UNITED STATES PATENT AND TRADEMARK OFFICE

APPLICATION NO.	FILING DATE	FIRST NAMED INVENTOR	ATTORNEY DOCKET NO.	CONFIRMATION NO.
10/786,456	02/25/2004	Christian Krueger	2000.109900	4909
23720	7590	06/15/2005		EXAMINER
				JOHNSTON, PHILLIP A
			ART UNIT	PAPER NUMBER
				2881

Office Action Summary	Application No.	Applicant(s)
	10/786,456	KRUEGER, CHRISTIAN
	Examiner	Art Unit
	Phillip A. Johnston	2881

Detailed Action

FIG. 1

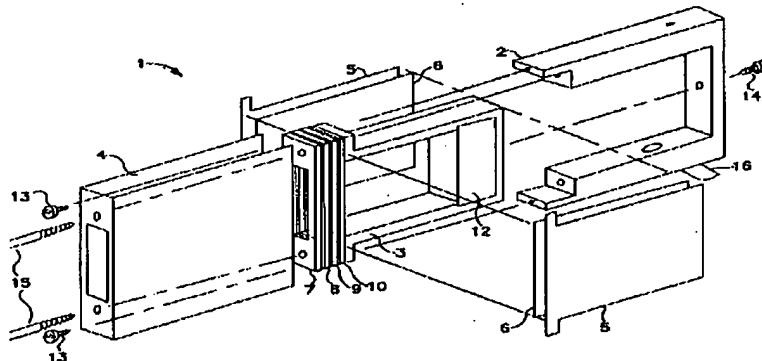
Turner (002) discloses a Faraday cup design including a bottom 12, walls 6, aperture 4, and plural aperture plates 7-9; where the conductive collector surfaces; e.g., inner cup frame 3, substrate 12 and aperture plates 7-9, are insulated from each other and have different orientations to the ion beam, as recited in claims 1-12, and 26-34. See Column 4, line 23-52; Figures 1 and 2 below.

FIG. 2

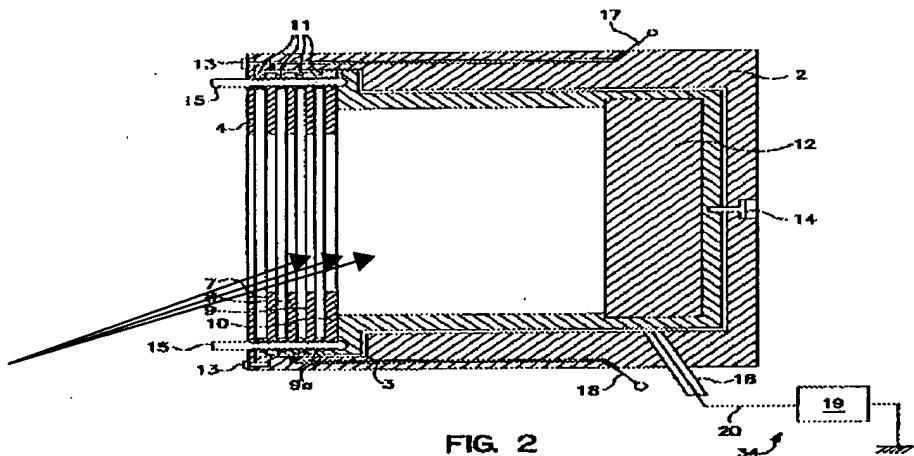
In addition, it is implied in Figure 2 above that, aperture plates 7-10, are each conductive regions positioned at different angles (see arrows) relative to a single point on the longitudinal axis, as recited in claims 10-12.

FIG. 1

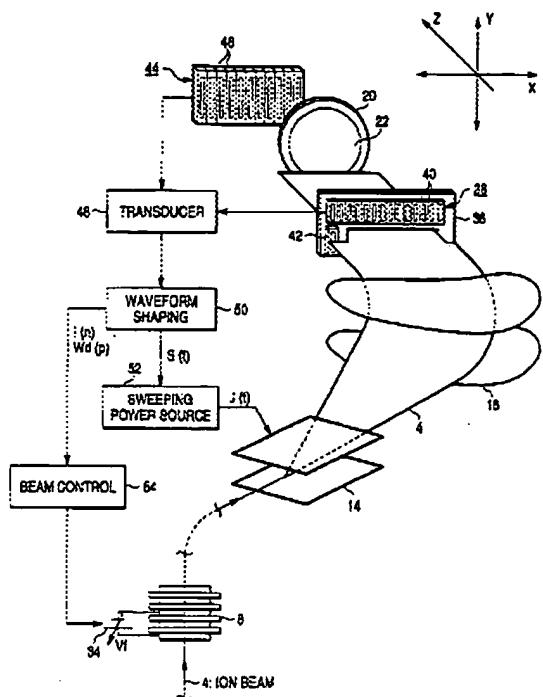
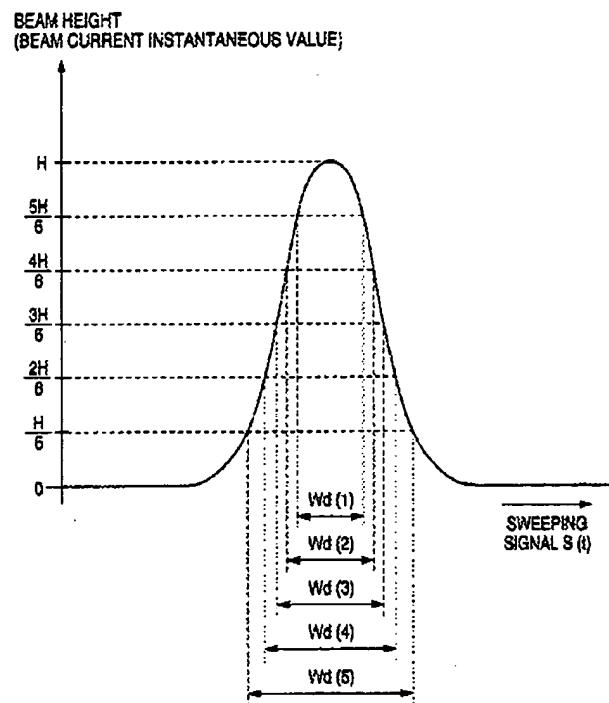
Iwasawa (027) discloses an ion implantation apparatus; wherein the beam width is measured using a plurality of faraday cups 40 and 46 positioned to collect ion current across the beam and generate a beam width waveform shown in Figure 3 below. Thereafter beam controller 54 is used to control divergence of the beam, as recited in claims 13-25. See Column 3, line 16-39; Column 5, line 41-50; Column 6, line 51-67; Figures 1 and 3 below.
